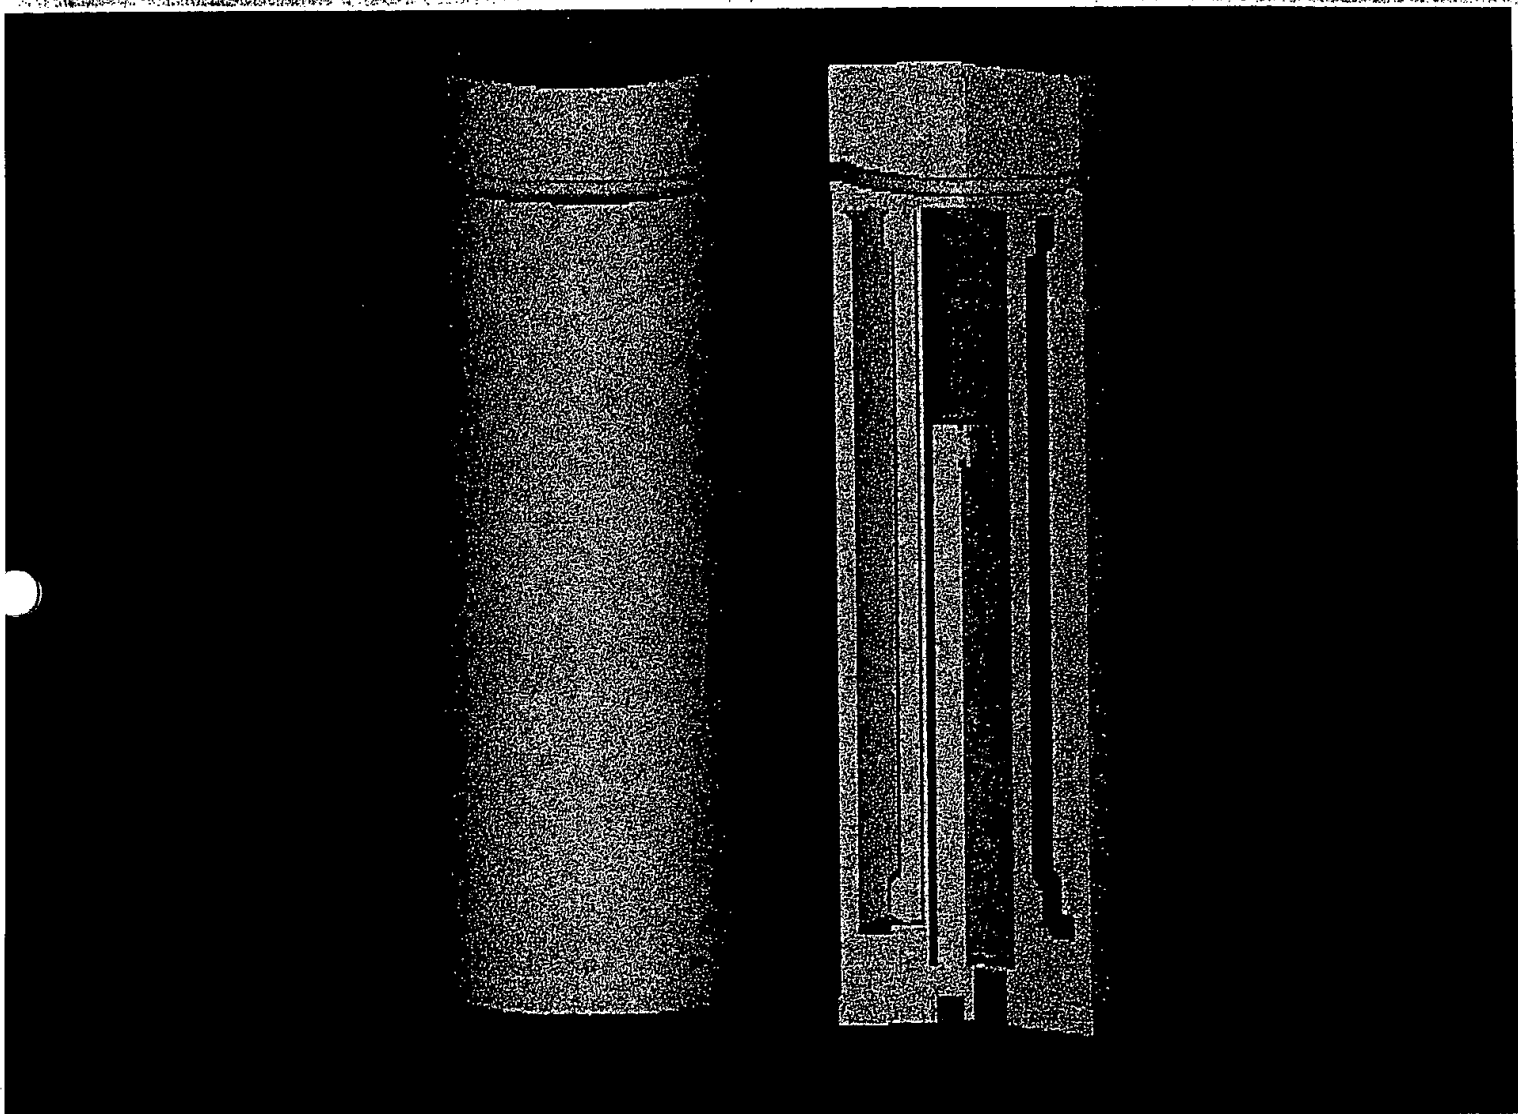
- Possible new feature: Transparent polymer cap to inspect unit functioning.
Pressure regulator included?

- wasted space bet. filter & housing →
 - a. provide insulative material to occupy space.
 - b. use centrifugal action of oil flow in space to swing out particles.
 - c. Add extra filter element around mid core.
- Oil pressure inline lets contaminants drain back to engine.
 - a. provide coiled tube w/ holes for oil exit & dispersion.
 - disperses heat from incoming oil, providing less element melting.
- If filter is snug against evaporation tube, and holes are at top of tube → filter life compromised and oil stagnation results. If oil drains back down through filter (holes at bot. of tube) → easy inspection of filter element.
